**RE: Request for Permit to Operate
Cell 1 Industrial Landfill
International Paper Industrial Landfill Permit # 24-02
Riegelwood, North Carolina**

**RE: International Paper
Riegelwood, North Carolina
Cell 1 Construction
Anchor Trench and Geocomposite Installation**

**RE: Permit Modification
Request for Specification Revision
International Paper Industrial Solid Waste Landfill
Facility Permit Number 24-02
Riegelwood, North Carolina**

Re: **DESIGN MODIFICATION NO. 1**
International Paper
Riegelwood, N.C.
Industrial Landfill Permit Number 24-02
Cell 1 Construction

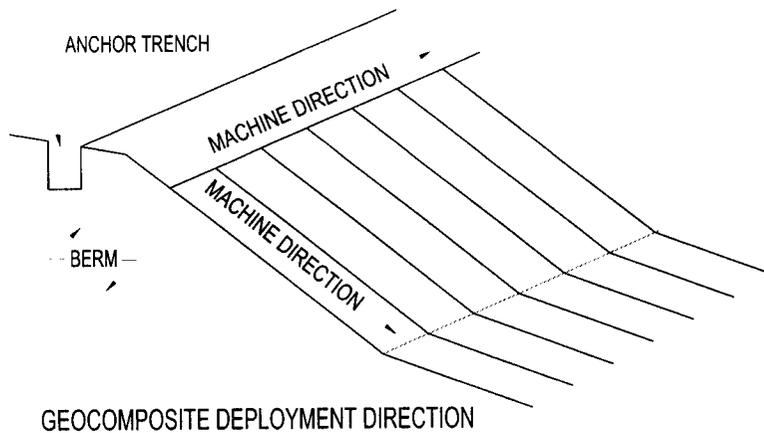
Just to keep you up to date on the latest events at the International Paper landfill construction in Riegelwood, we are having some difficulty keeping the anchor trench open after rain storms. You may recall that the liner system is a 5-layer synthetic sandwich, with 40-mil HDPE, a geocomposite, a GCL, a 40-mil HDPE primary liner and a primary geocomposite. A sketch of the anchor trench is shown below.

To install the synthetics in such a way as to minimize the time that elapses until the anchor trench is backfilled, the installer wants to place all of the layers of geosynthetics into the trench as quickly as possible. This means that the anchor trench will not be backfilled in lifts as is shown on the permit drawings. As we discussed in the geosynthetics pre-installation meeting on May 13, this minor change can be covered in the as-built drawings.

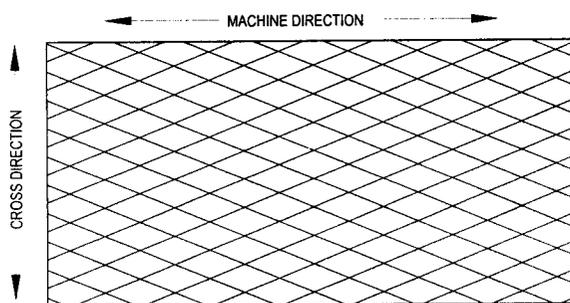
A second change involves the direction of deploying the uppermost geonet composite (geocomposite). As is typical in geosynthetic installations, the synthetics will run down the slope to the floor. The exception is the primary geocomposite. It will run with the anchor trench. In other words, each roll of the primary geocomposite will run about 14-feet out of the trench, and 200-feet along the trench. The sketch below illustrates the proposed deployment direction.

As you can see in the above sketch, the first panel of geocomposite will be run with the machine direction parallel to the anchor trench and across to the slope, but the remaining panels will be run with the slope. Nothing in the project specifications prohibits installing the geocomposite this way, but it is usually run with the slope. I talked with Perry Vass, an engineer with the geocomposite manufacturer about the proposed installation. He said that there might be a reduced transmissivity in the cross direction. I told him that since the only panel that would possibly get flow in the cross direction is the one at the top of the berm, but there should be very little flow at the top of the berm anyway.
